Town of Faro Request for Tender #2017-06
ADDENDUM #2 R1
Faro Recreation Centre Generator Installation

ADDENDUM No. E01 R1

PROJECT (No.)	Faro Recreation Centre Generator Upgrade (15066)	ISSUED DATE	24 July 2017
ISSUED BY	Martin Slama, EIT	Dorward Engineering

Attachment 02

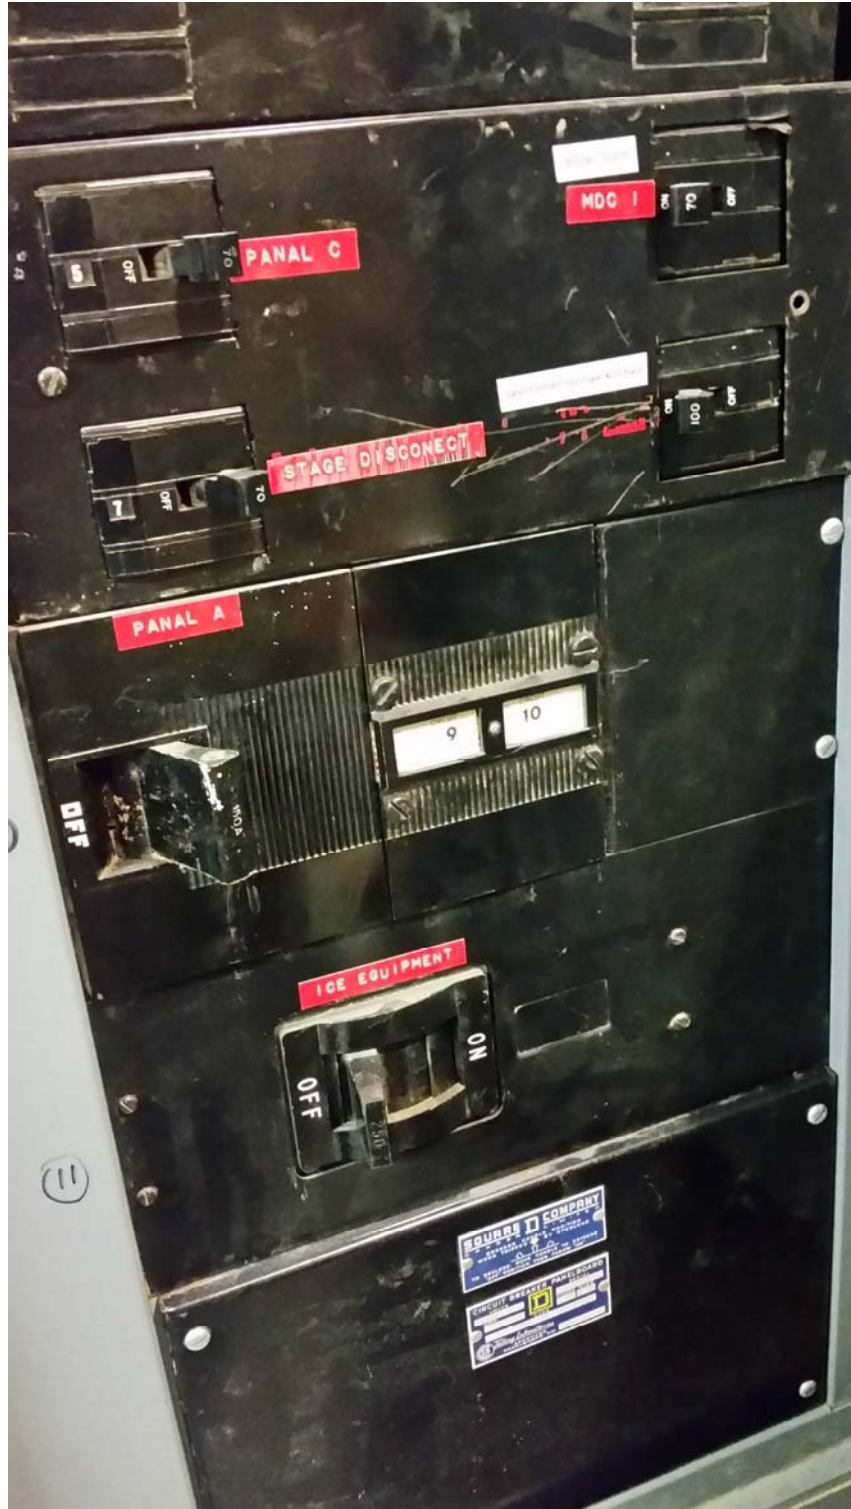
ITEM	DESCRIPTION
1.	Detail 1/E1 – New LED fixture to match existing, see attachment A1.
2.	Alternate Pricing - Item 1 new ATS – Provide alternate pricing for a new, single by-pass, automatic transfer switch rated minimum 400Amps 120/208V 3-phase 15kA interrupting current.
3.	Alternate Pricing - Item 2 new CDP - Provide alternate pricing for a new CDP with sufficient capacity for all existing breakers, plus two additional breakers rated minimum 3-pole 100Amps. Rated minimum 3-phase 400Amp 208V. See attachment A2 for existing CDP breakers.

Generator room site conditions: Existing CDP
